A303 Sparkford to Ilchester Dualling Scheme TR010036

9.36 Responses to Action Points for Deadline 7

Responses to Action Points for Deadline 7

Figure 2.2: Dialux Visualisation of 'most focussed' lanterns on NMU route in Hazlegrove Underbridge

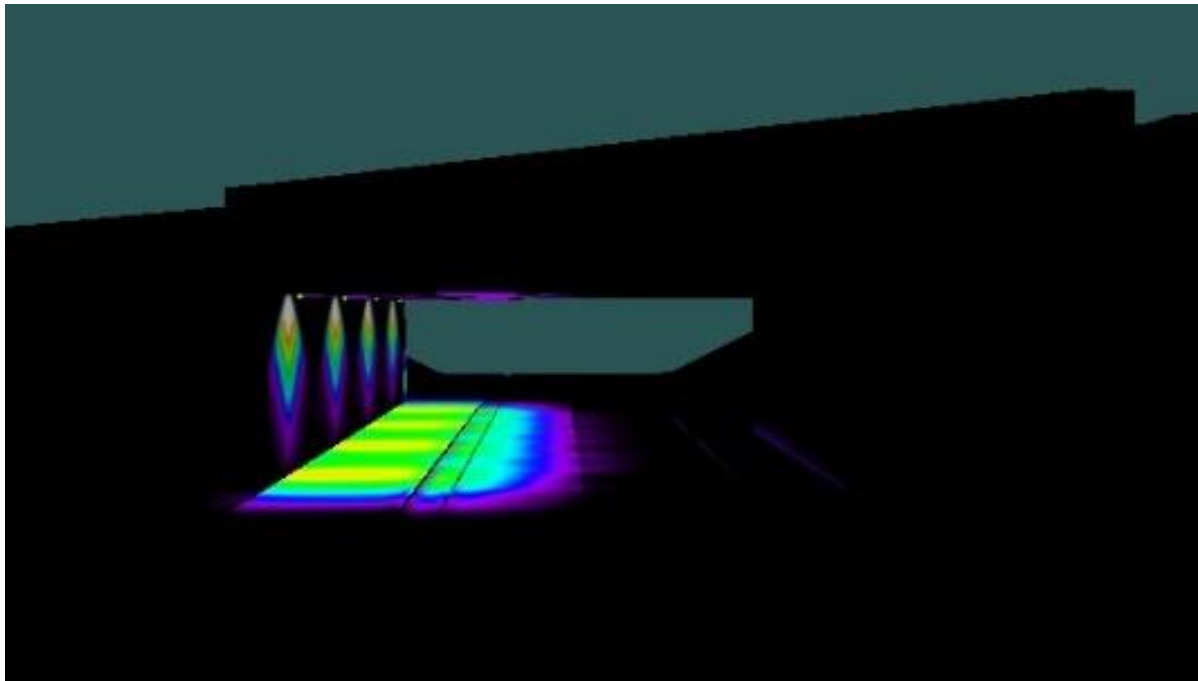
- 2.1.54 Figure 2.2 shows a luminance visualisation of the underbridge where lighting is provided along the NMU route using the most concentrated light spread possible, in order to minimise light spill onto the adjacent carriageway.

- 2.1.55 The visualisation in Figure 2 demonstrates that, where the NMU route is lit but the adjacent road is not lit, the view of on approach to the underbridge will be unorthodox with the opposing half of the bridge in darkness. This unusual view may distract drivers and lead them to veer towards the lit side, possibly crossing lanes or mounting the kerb.

- 2.1.56 As the road through the underbridge is unlit, lanterns lighting the NMU route will appear disproportionately bright and cause potential glare to drivers. NMU route and any users / objects within it will be significantly better lit than the route ahead for the driver and likely cause distraction to them.

2.1.57 The Applicant's designer therefore considers that the approach to illuminating only the NMU route as shown in Figure 2.2 would be unsafe to drivers and non-motorised users.

Figure 2.3: Dialux visualisation of 'more dispersed' light spread

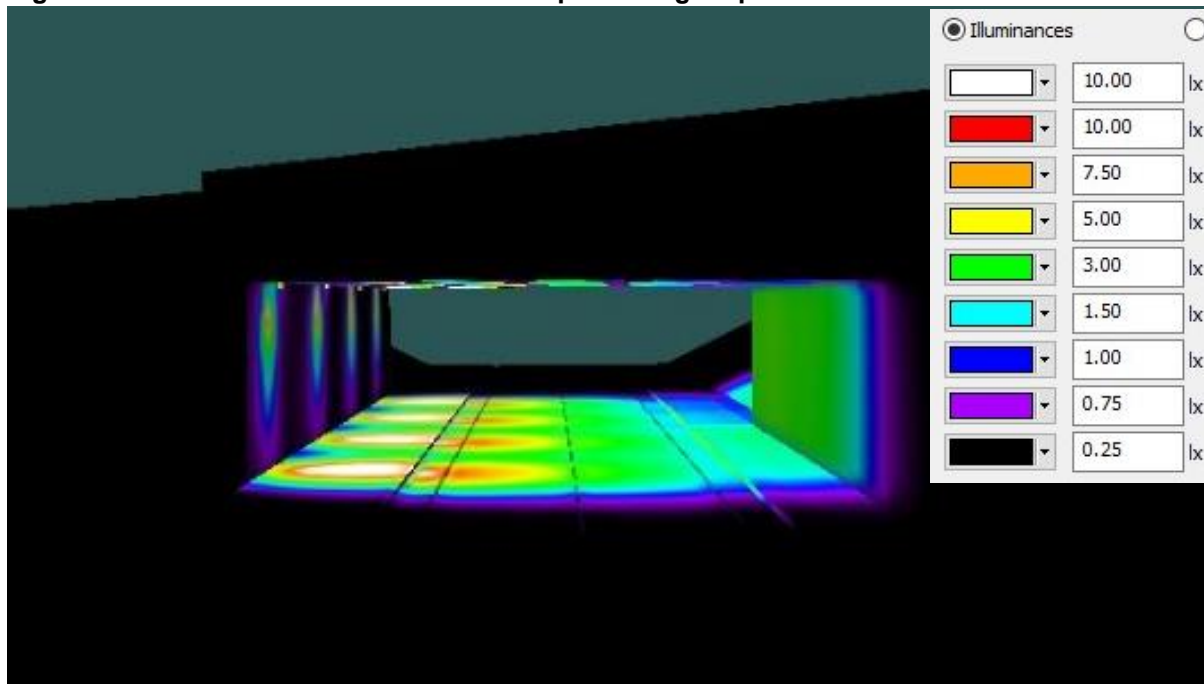
2.1.58 The Applicant's designer has investigated a 'compromise' between the solution shown in Figure 2.2 and a possible solution where the light spill from the NMU route covers enough carriageway to avoid driver distraction but not enough to require illumination of the carriageway approaches. In order to do this, less concentrated lantern units have been assessed in the Dialux software. The results are shown in Figure 2.3.

2.1.59 Figure 2.3 shows that the carriageway, NMU route and verge are likely to be more apparent to approaching drivers, therefore avoiding the distraction issues described above. However, Figure 3 shows that there is a considerable variation in luminance levels along the lane adjacent to the NMU route. The consequent 'flicker' effect would not be consistent with guidance in HSG-38. Furthermore the level of the light on the carriageway is significantly lower than the lighting classification requirements set in BS5489. Therefore, although the road may appear lit, it would not be lit in compliance with the lighting requirements set out in BS5489. Once illumination is provided along a road it is not appropriate to only illuminate this carriageway or part of it to levels lower than those in BS5489.

2.1.60 With reference to previous responses regarding this matter, the Applicant considers that there is no justification for the provision of illuminance on the carriageway, that is not compliant with the requirements of BS5489, or that is inconsistent with guidance regarding differential lighting levels and glare given in HSG-38. There is no identified security risk that warrants the provision of a non-standard, sub-optimal lighting system at this location.

Figure 2.4: Pond 1 with a 6 metre maintenance strip

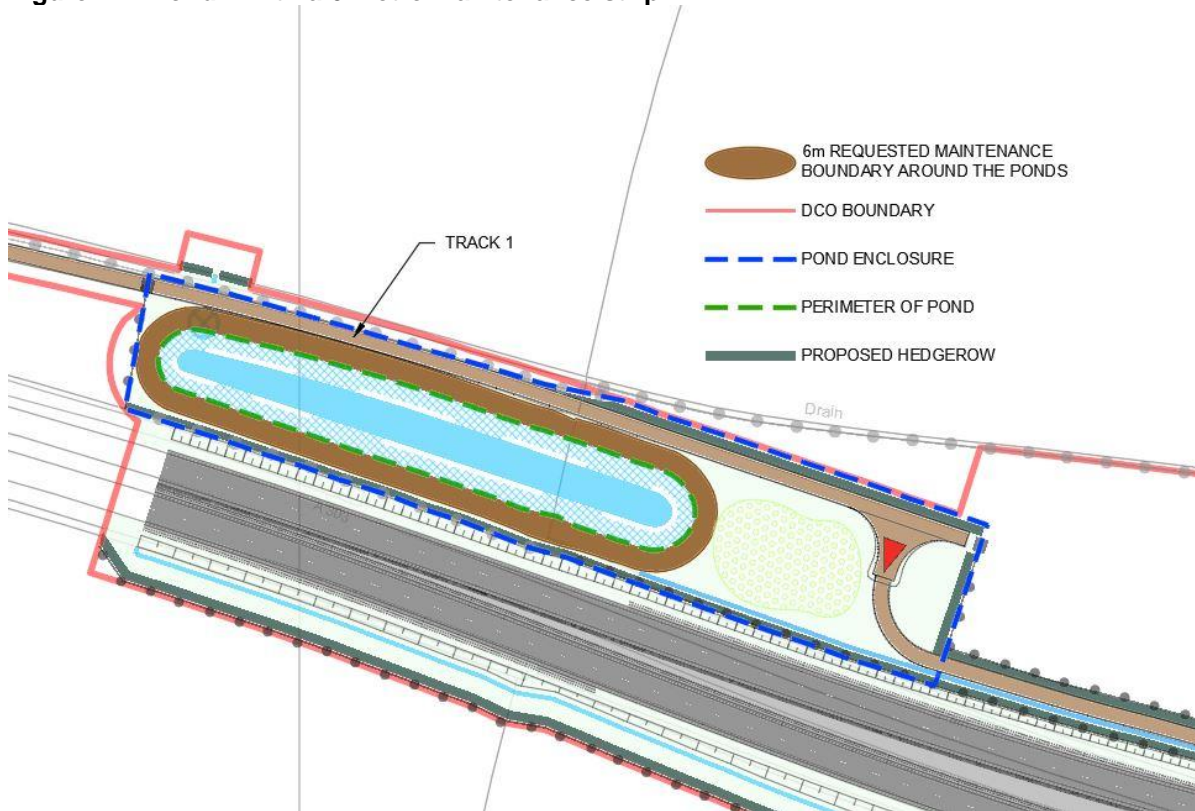
2.1.106 Action Point 25 requests: *Ponds – 6m access for maintenance. Submit plans showing where this can and cannot be met.*

2.1.109 In the case of Pond 1, a maintenance strip of 6 metres width is not currently possible within the proposed design. However a 6 metre strip will be possible with a very minor rearrangement of elements within the pond enclosure. This includes moving the pond slightly further north and rearranging the area of planting located at the pond's eastern edge. This solution is presented in Figure 2.4.
